Variant name: TE0803-04-4BI21-X

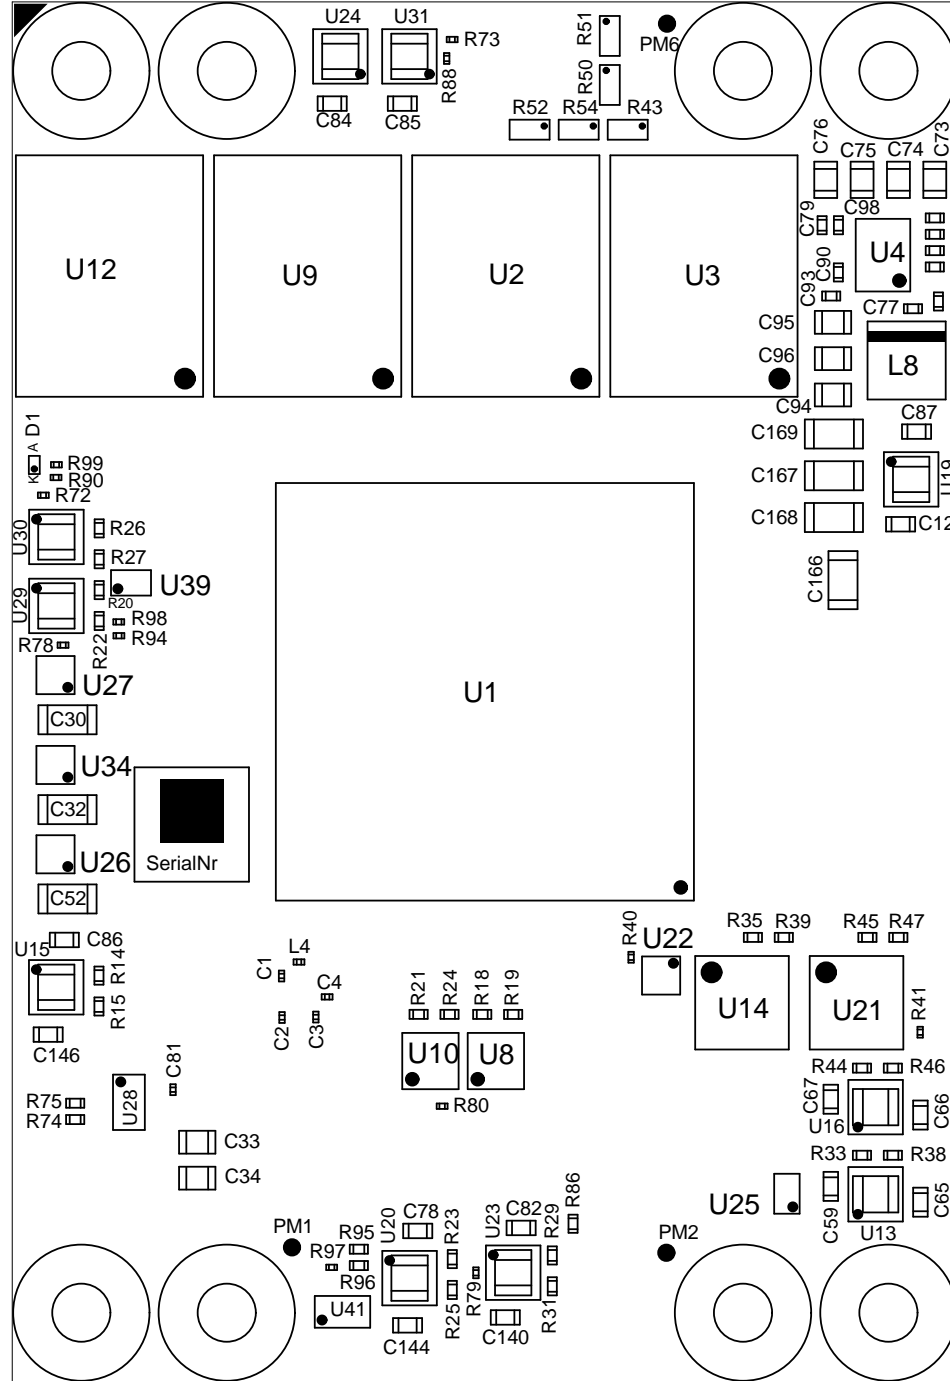
U41 Power supervisor TPS3106K33DBVR replaced by
Schottky diodes SBAS70-04LT1G
